Addendum Review of Environmental Factors

Re-development of the Blayney Multipurpose Service Facility –
Addendum 2

25 February 2025

Figure 10: Extract of Original Approved Elevations- east of RAC and north (top image) and Proposed Amended Elevations (bottom image)

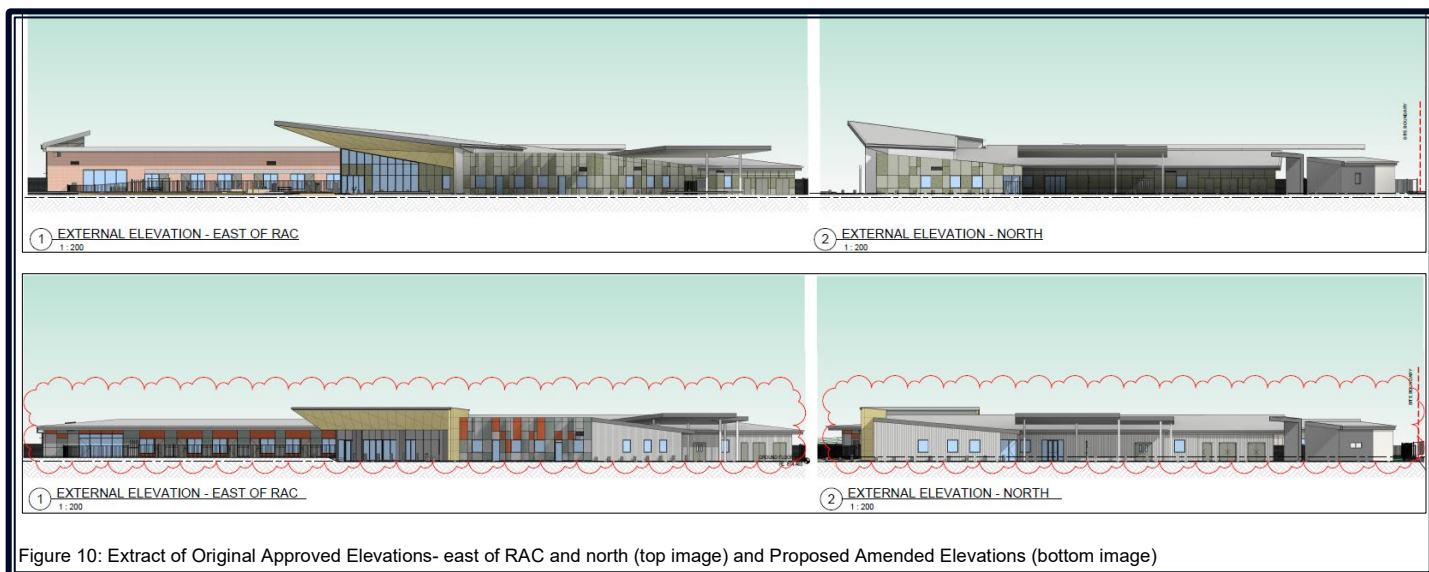
- Rationalisation of the main entry roof awning design (e.g. depth, pitch and size) – see **Figure 10**, **Figure 11** and **Figure 12**;
- Removal of separate elevated roof elements and their replacement with skylights within the main roof element – see **Figure 13** and **Figure 14**;

Figure 14: Extract of Original Approved Elevations – RAC / IPU - RAC Courtyard, west and north (top image) and Proposed Amended Elevations (bottom image)

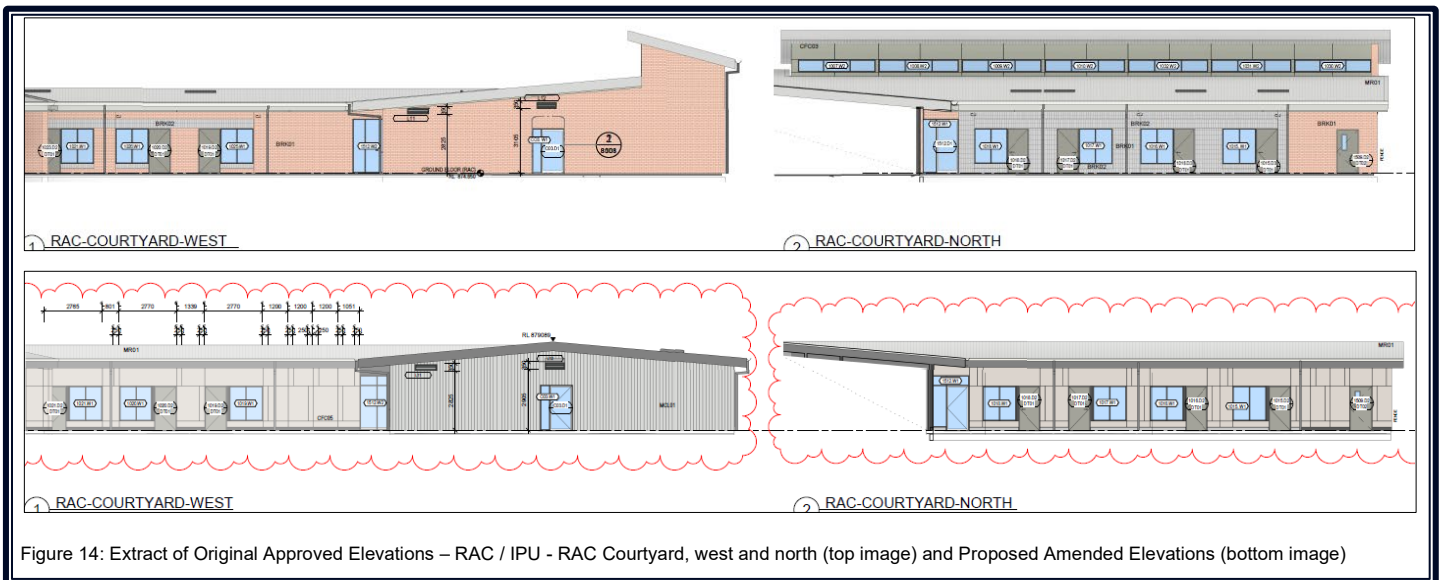
- Amendments to façade form and extent of selected main building elements, in response to roof form changes e.g. see **Figure 14** to **Figure 17** inclusive;

Figure 20: Extract of Original Approved Elevations – H1 - south-east (top image) and Proposed Amended Elevations (bottom image)

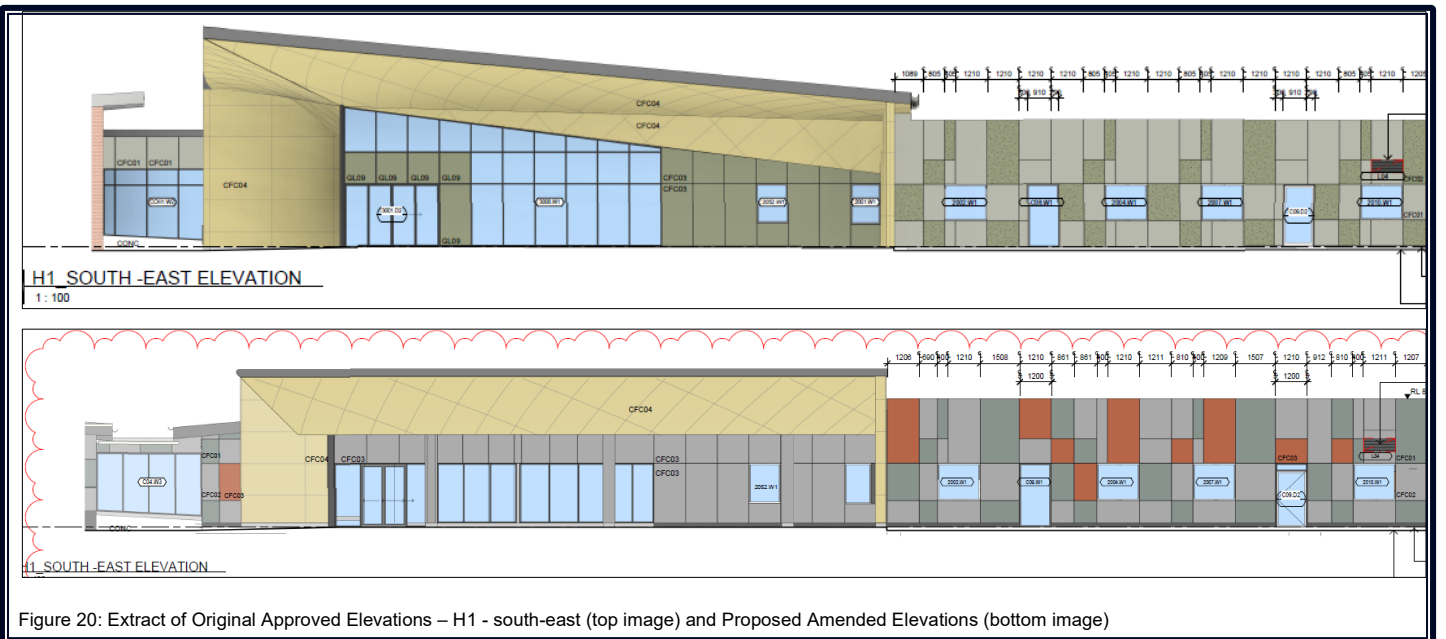
- Reduction in the vertical extent of window and door glazing along selected facades of the main building e.g. at the main entry – see **Figure 20** and **Figure 21**; and

Figure 22: Extract of Original Approved Façade Materials (left image) and Proposed Amended Façade Materials (right image)

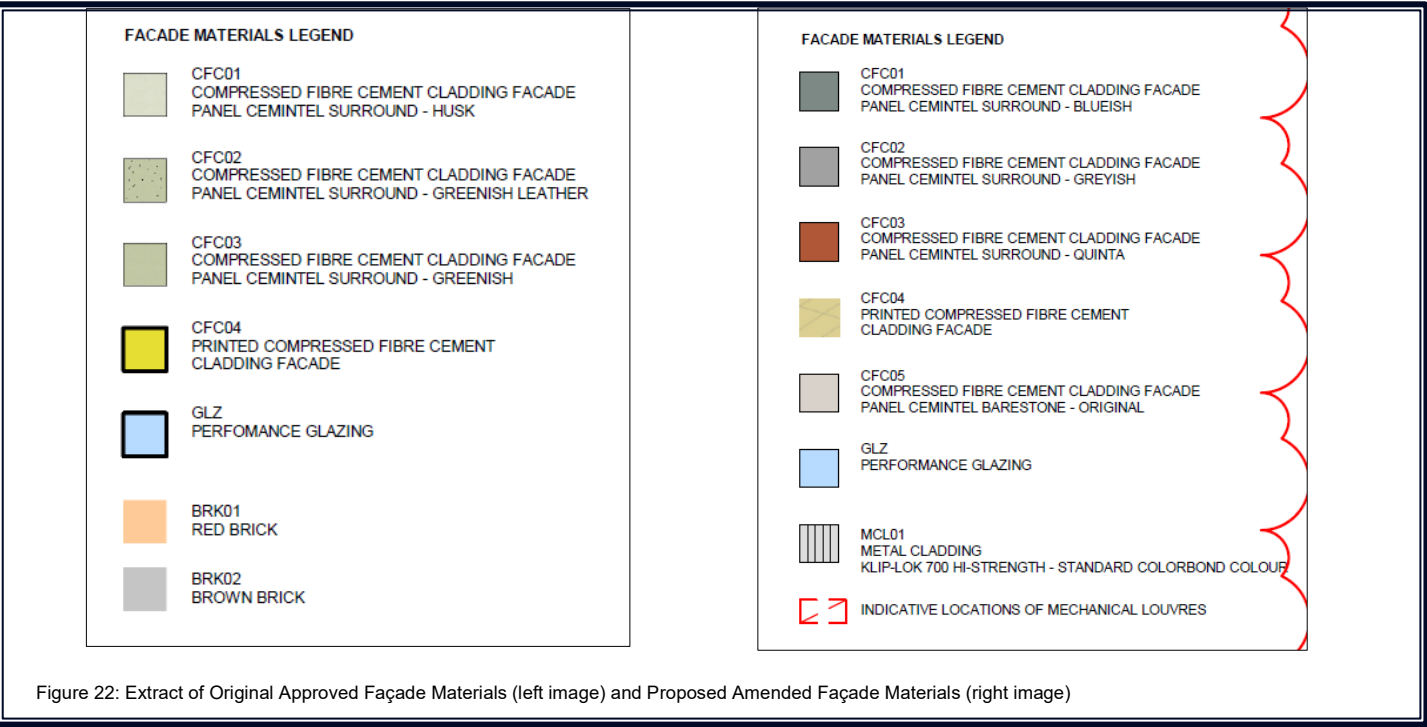
- Changes to facade materials for selected main building elements – see **Figure 22**.
